**December 8, 2022**

**Re: Th16c - Application No 6-23-0342, Kate and AJ Pollock, 529 Pacific Avenue, Solana Beach**

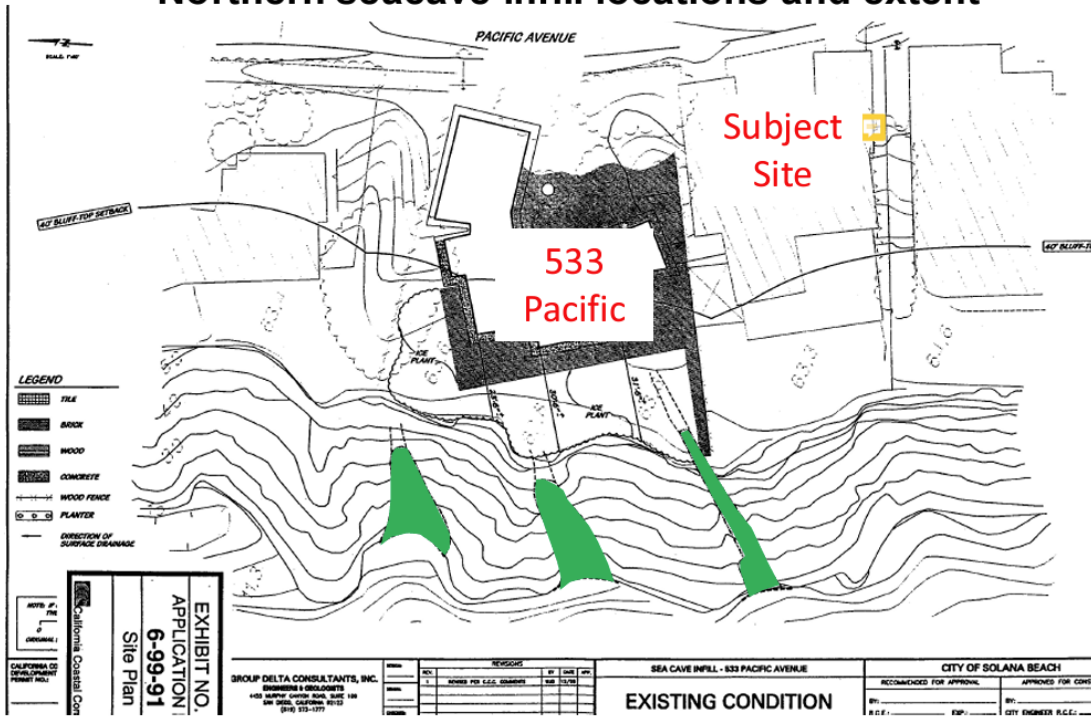
This newly revised calculation of an historical erosion rate of 0.19ft/yr appears to depend on the presence of shoreline protection devices including seacave fills at the subject site. The Commission's engineer determined the historical erosion rates by aerial photographs (Exhibit 8 page 3, Supplemental Memo: Revised Geologic Setback Analysis):.

Retreat rates determined in this way would inherently be biased by the presence of the seacave fills as deep as 75 ft in the immediate vicinity of the site. These caves were filled as early as 1987 and at the latest by 2000, with additional fills and repairs in 2014.<sup>3</sup> Thus aerial photography methods of determining erosion are biased by the presence of this coastal armoring. Exhibit 4 shows the seacaves as filled by the neighboring property's permits.

## Northern seacave infill locations and extent

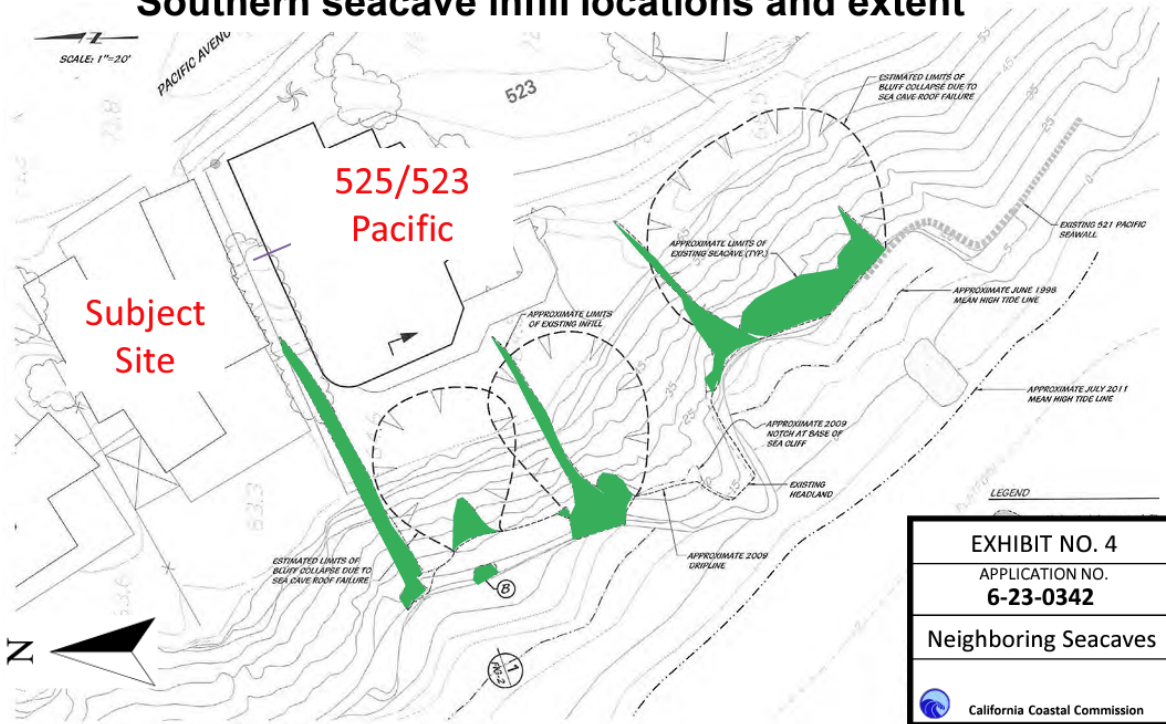
The retreat analysis using aerial photos inherently includes the fact that seacave infills reduce erosion rates. Such an analysis is in direct contradiction with Coastal Act Section 30253 requirements that new development setbacks not rely on the presence of shoreline protection. Using shoreline protection in determining the GSL is also contrary to the GSL requirements in Solana Beach's certified LUP. The GSL must be determined absent the presence of shoreline protection per the certified LUP.

A more appropriate methodology would be to take core samples to determine the geology of the bluff and then perform stability analysis for those segments as well as including the impacts of seacaves if they were unfilled. For this reason alone, we believe the historical erosion rate and the GSL are vastly underestimated and must be revised to remove any doubt that shoreline protection was used in GSL determination. Furthermore, the core samples could not include cave infill material. Lastly, hydrological analysis of the expansion of these seacaves, if unprotected over the installed period and in the future, should be used to properly determine erosion rates. The expansion of these caves should have been factored into both historical and predicted retreat rates, but erroneously this has not been done. The aerial photography or observed retreat rates inherently remove the impact of these long existing seacaves on erosion rates.

page B-113, Figure 5.2-40 Simulated Bluff Failures at Reach 8 without Sea Level Rise	Page B-114 Table 5.2-6 Modeled Bluff Retreat Averaged Over 1000 Simulations Under Without SLR conditions
---	---

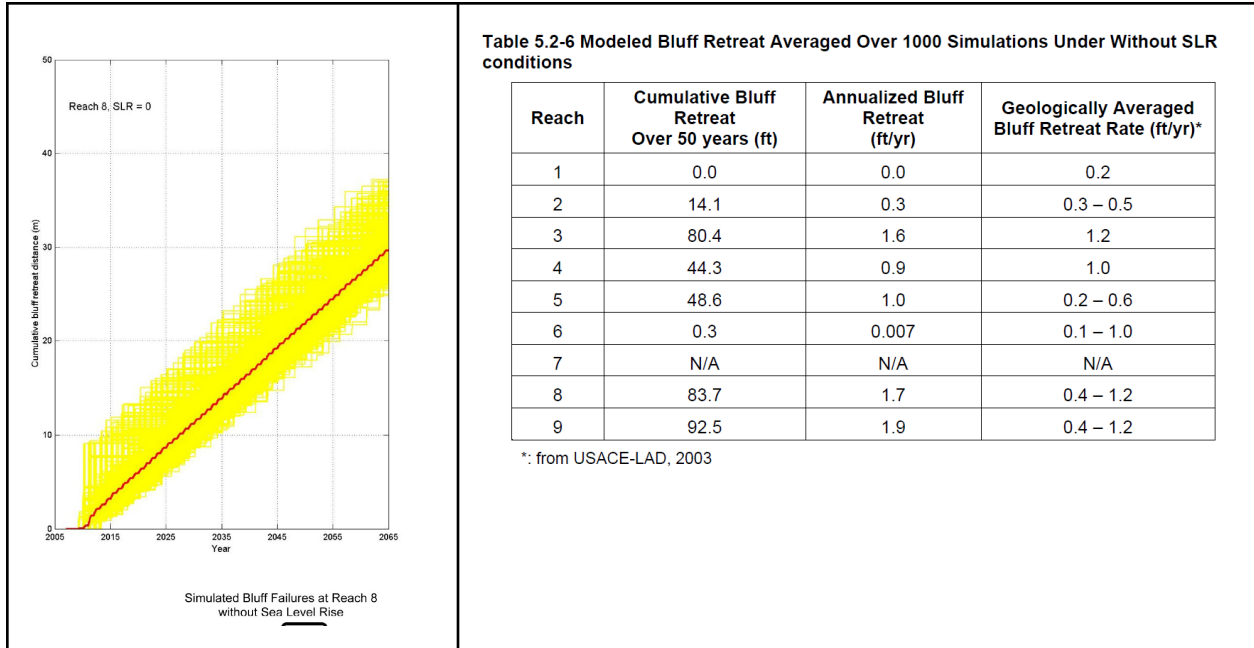
See also Encinitas-Solana Beach Coastal Storm Damage Reduction Project. San Diego County, California, Appendix C, Coastal Engineering at Appendix B, showing similar historical simulation absent SLR.<sup>6</sup>

Figure 5.2-48 Simulated Bluff Failures at Reach 8 Based on Historic SLR

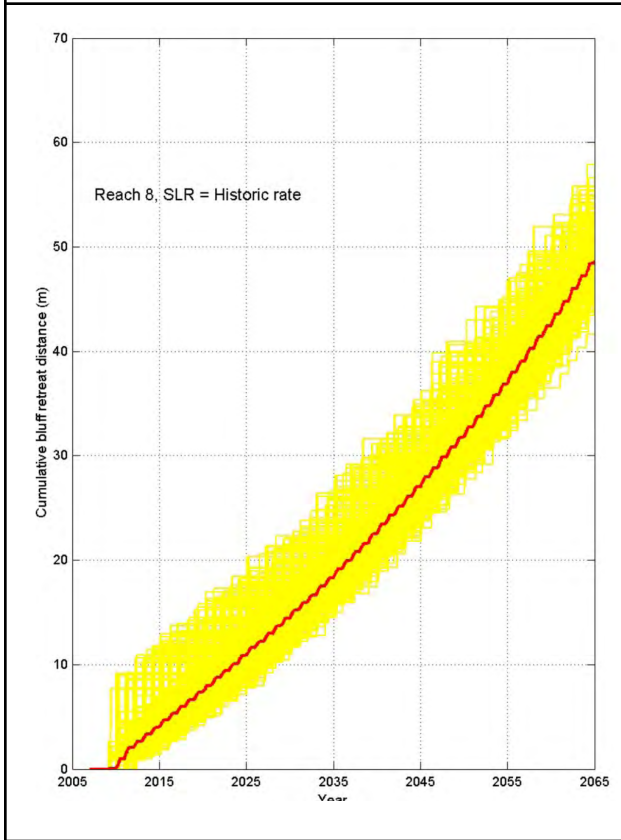
When sea level rise was included by the Army Corps, the results were even more significant even though the Army Corps used less aggressive SLR assumptions:

Figure 5.2-61 Comparison of Predicted Mean Bluff Retreats in Reaches 8 and 9 Appendix B – Coastal Engineering Encinitas-Solana Beach Shoreline Study (page B-135)

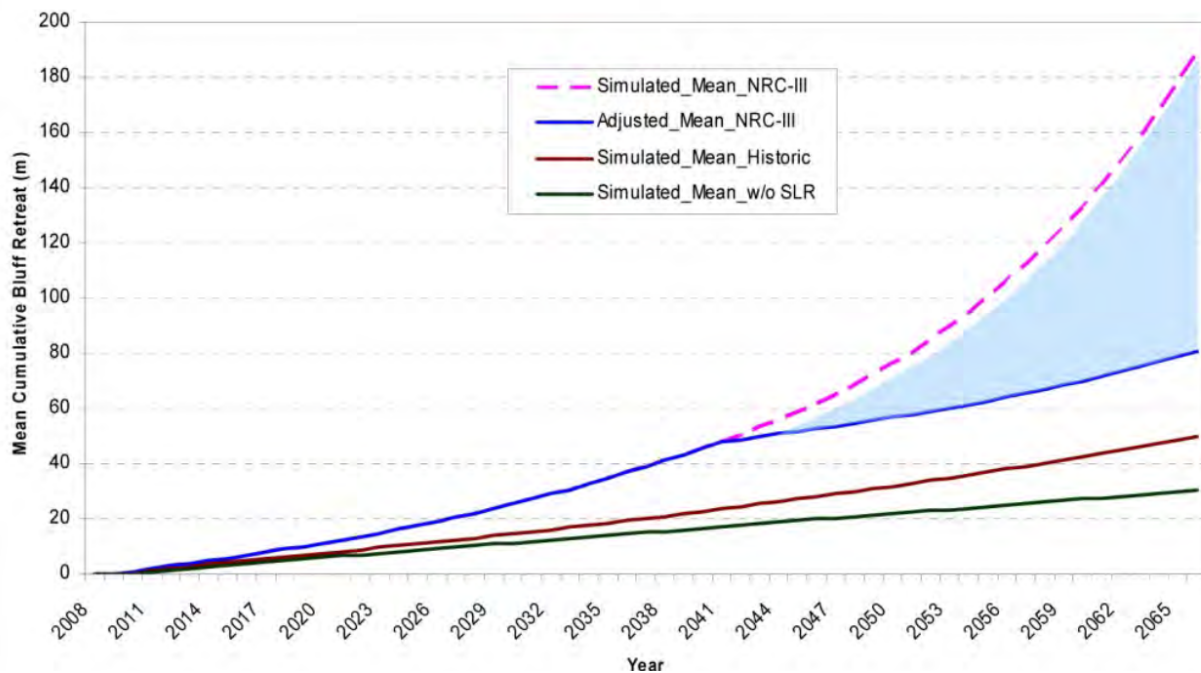
The Army Corps found much higher erosion rates at the subject site. These rates were certified in the Federal Consistency Hearing on 11-11-2013 and by the City of Solana Beach when it certified the EIR/EIS and by the Army Corps when it certified the project.

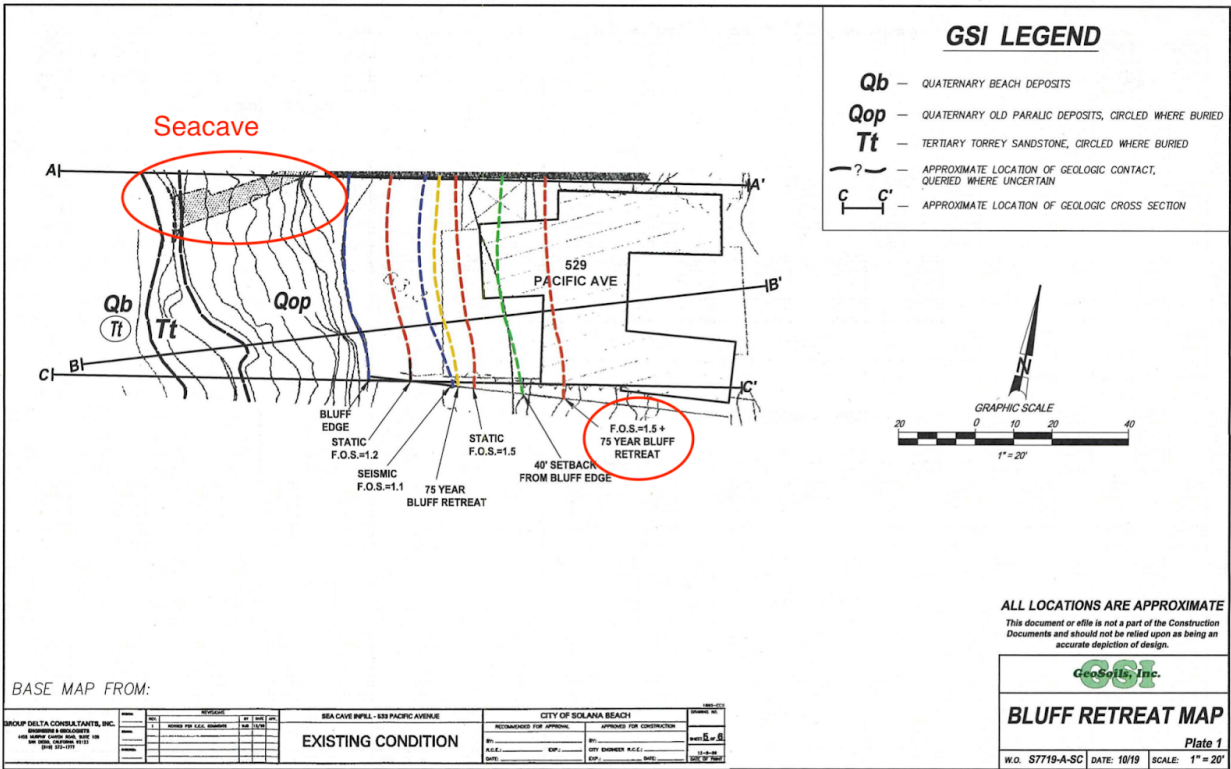
We also believe that due to errors and omissions in the applicant's Geological Report, their calculated retreat rate and GSL is incorrect. The City of Solana Beach's engineer stated, in his April 11, 2021 letter about this proposed project, that the stability analysis included material filled in the cave. He continued to state that the concrete in the cave behaved the same as natural bluff material. This analysis is inaccurate, as a filled cave is clearly more stable than an unfilled cave and is not the natural condition of the bluff. Additionally, stability analysis and therefore calculation of the GSL cannot take into account shoreline armoring per Solana Beach LUP:

Including cave fill for the determination of the GSL was therefore incorrect. We do not believe the Commission Geologist's Report removed the additional stability provided by the seacave fill when determining stability and GLS setback in the 2022 staff report. While the 2022 recommendation to deny remained unchanged as either way the proposed development is seaward of the GLS, the situation is even worse than presented by the current geotechnical reports.

The plate below from GeoSoils report indicates the criticality of proper determination of the GSL. (Plate 1, page 74 of City's 2021 staff report). The GSL indicating a Factor of Safety of 1.5 and 75 years of erosion is represented by the red dotted line on the right, landward of the 40 feet setback. Also visible in the plate is a filled seacave which is a shoreline protective device. This is shown by the gray shaded area (circled by us in red) that intersects the cross section A-A'.

## Northern seacave infill locations and extent

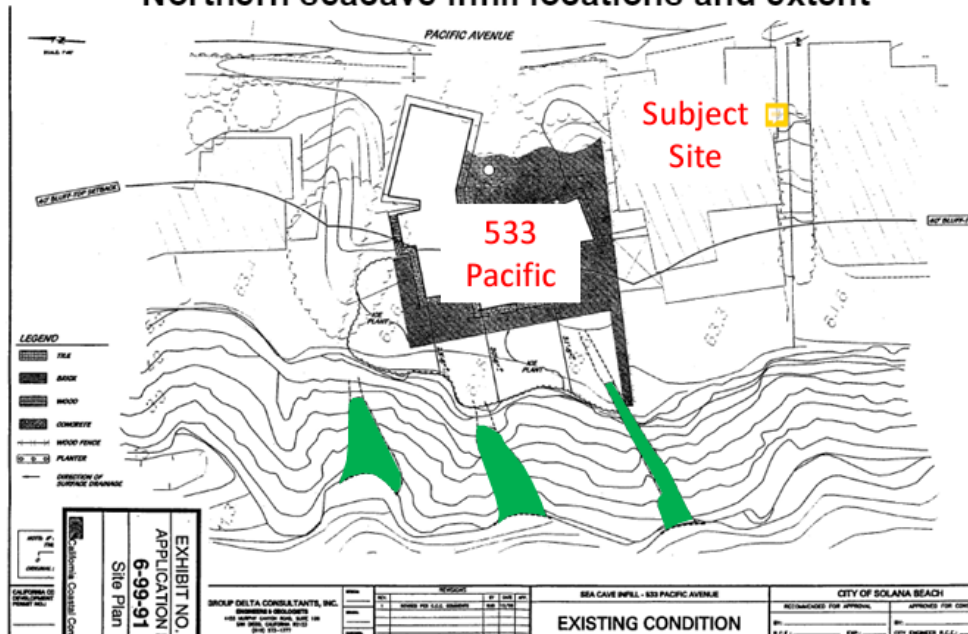
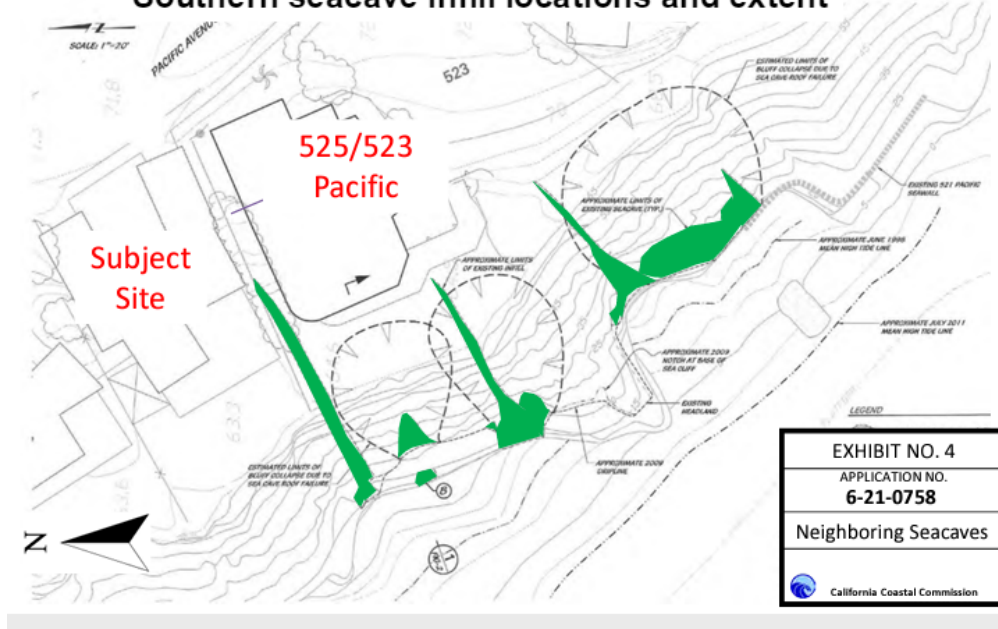
From the above exhibits illustrating the northern and southern seacaves that bracket the subject site at 529 Pacific Ave, it is evident that the cross sections A-A' and C-C' traverse filled seacaves. Therefore, the stability analysis relies on shoreline protection of filled seacaves in the calculation of stability factors. This analysis is in contrast with the requirement that stability analysis not rely on existing shoreline protection. Therefore

we respectfully request that the stability analysis be supplemented with stability factors calculated assuming the seacaves are unfilled. In that way the Commission can rely on proper substantial evidence in making its findings to deny this permit.
